TRAFFIC LOOP LAYOUT SHEET #3	PROJECT NAME: WALLINGFORD - RUTLAND TOWN	
	PROJECT NUMBER: NH 2408(1)S	
FILE NAME: p04b050.dgn	PLOT DATE: \$DATE\$	
PROJECT LEADER: D.E.G.	DRAWN BY: C.A.K.	
DESIGNED BY: J.S.P.	CHECKED BY: D.E.G.	
IPARM FILE: p04b050+lp03.i	SHEET 39 OF 80

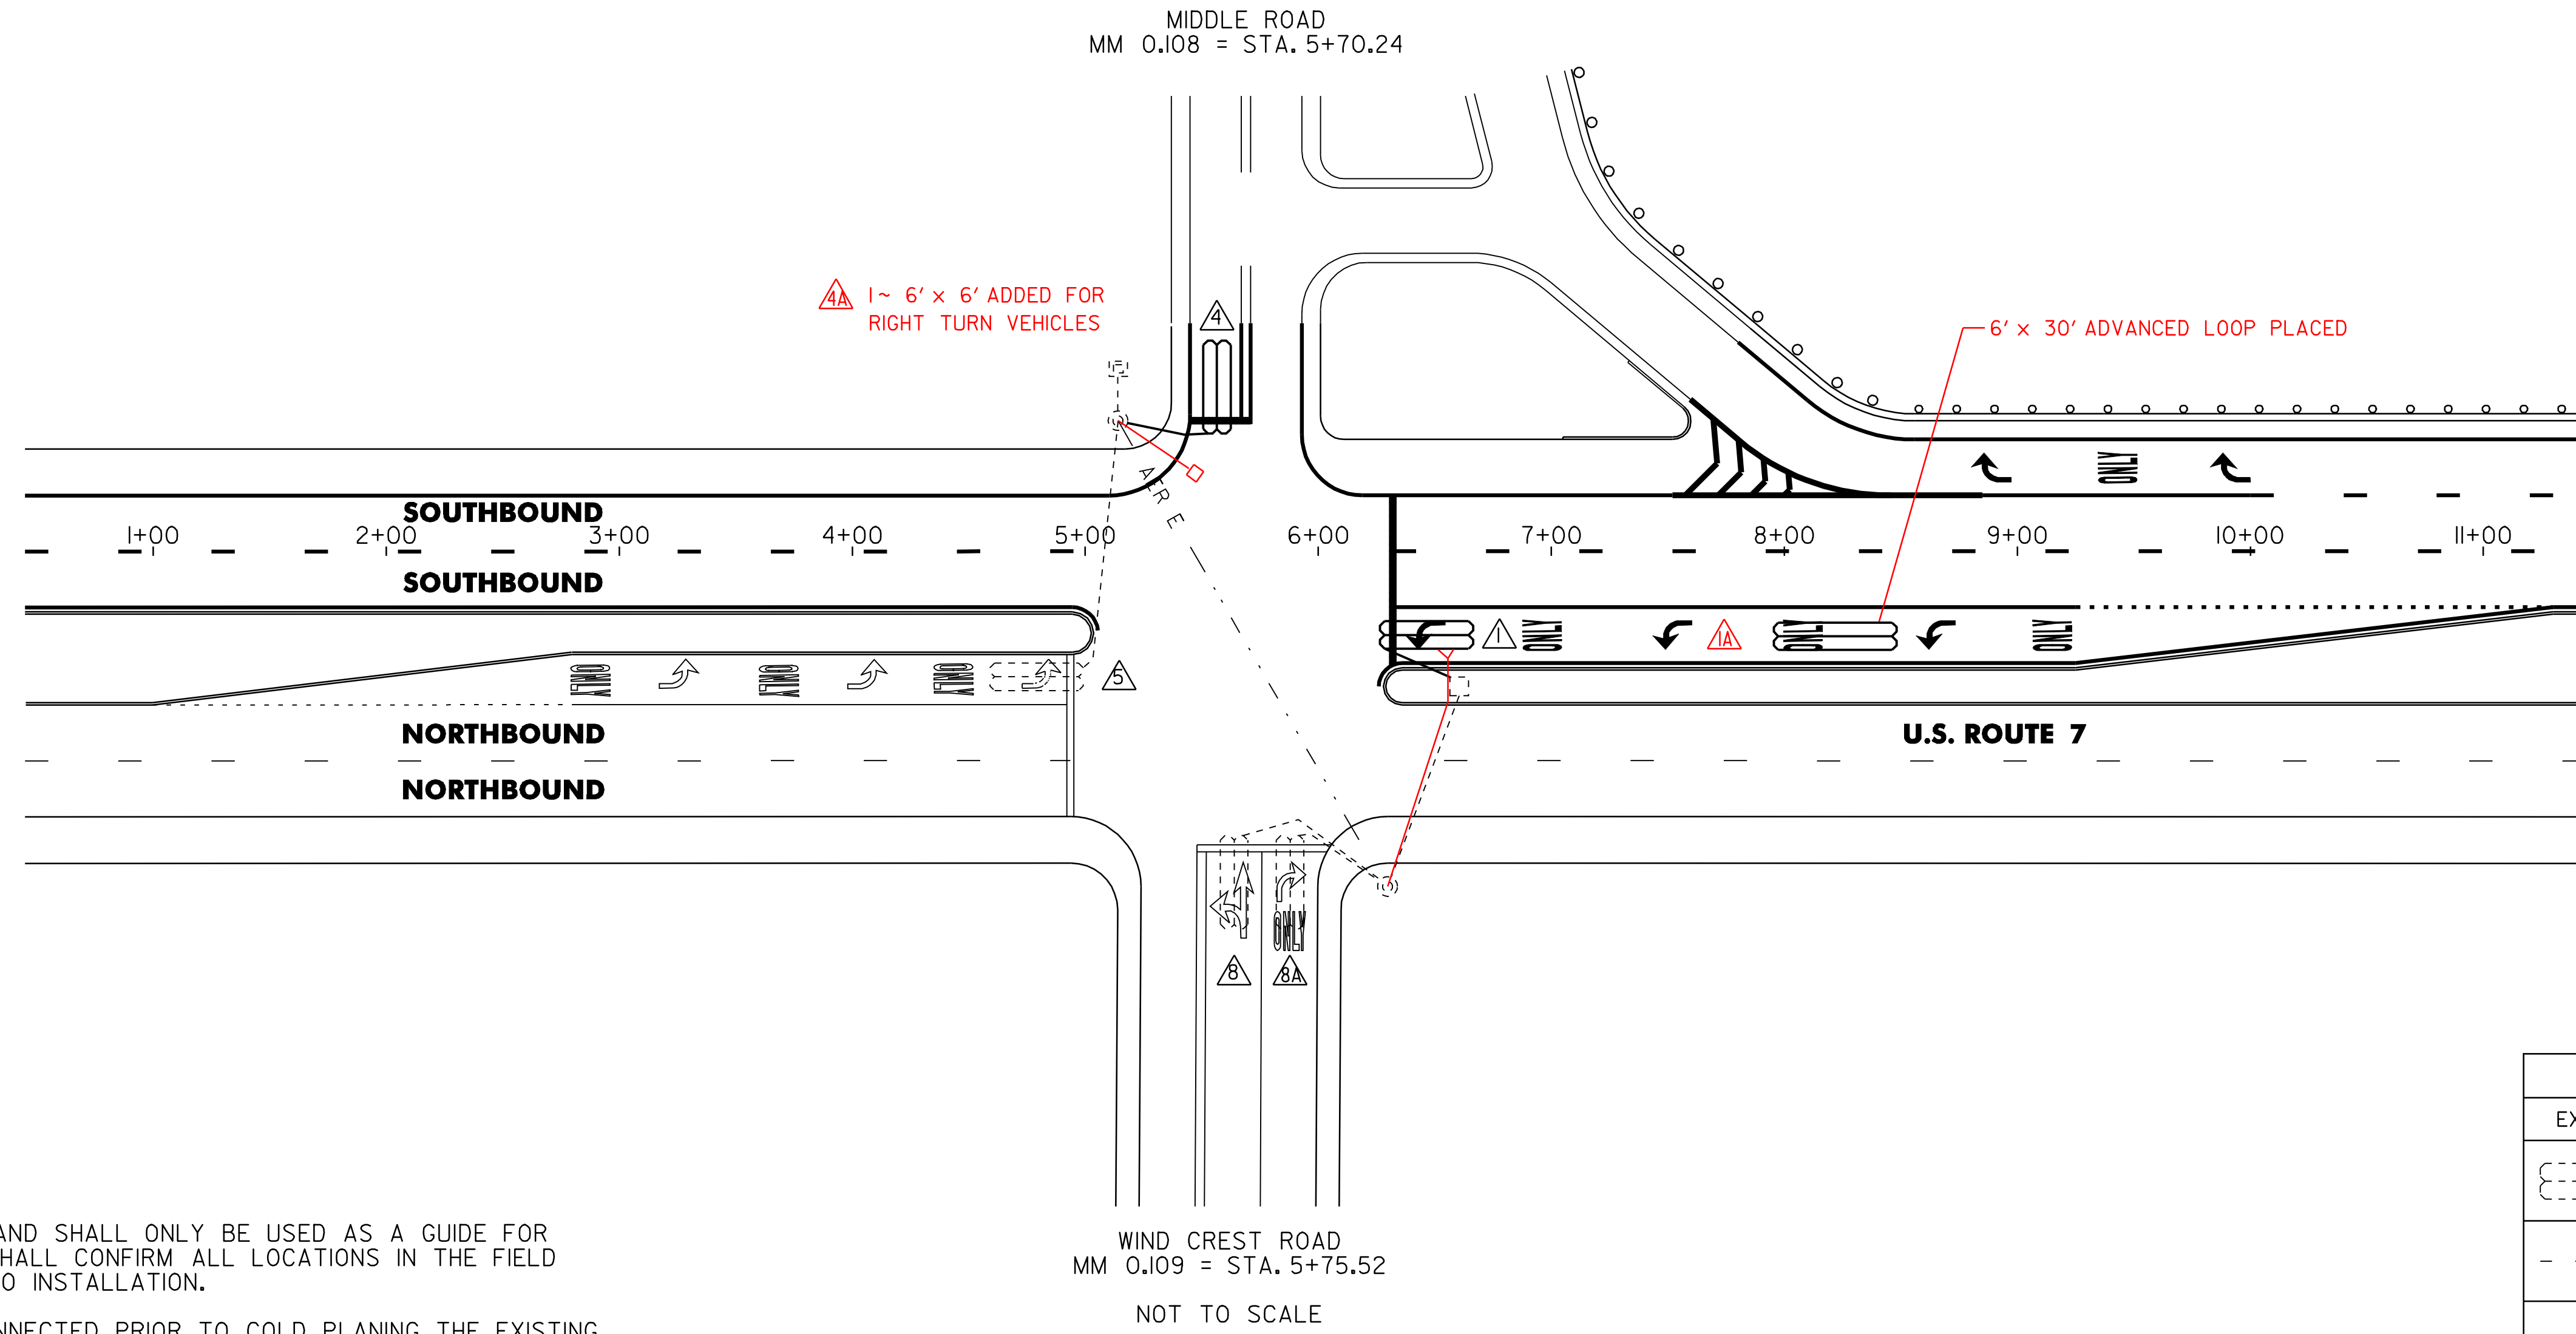
LOOP 1 - ~~148 FT~~ 168 FT
 LOOP 4 - 142 FT
 LOOP 1A - 106 FT
 LOOP 4A - 39.5 FT
